T.I. no.: 2015 - 05 Updated: -	Topic: Material fault in temperature sensor 063318
---	---

SUBSTITUTE DELIVERIES FOR TEMPERATURE SENSORS WITH MATERIAL FAULTS

Fault image of a corroded temperature sensor (063318)

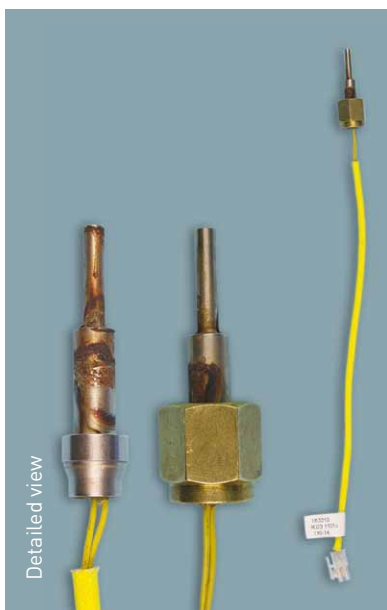
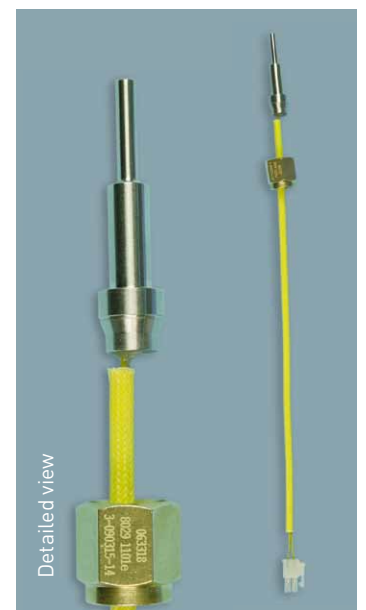
Due to a material fault on the part of the supplier, in the period CW40/2014 up to and including CW10/2015, temperature sensors were installed and supplied as a spare part that may corrode and fail (see left-hand diagram). This relates to article number 063318 temperature sensor NTC crimp plug.

The revised version of the faulty temperature sensor will be tested straight away. During this transition period, temperature sensors from another supplier will be used (see centre diagram). These are tested and approved.

When ordering 063318 during the transition period, the temporary solution will be shipped.

Temporary solution for temperature sensor with copper ring (068423)

New temperature sensor with identification on the nut (063318)
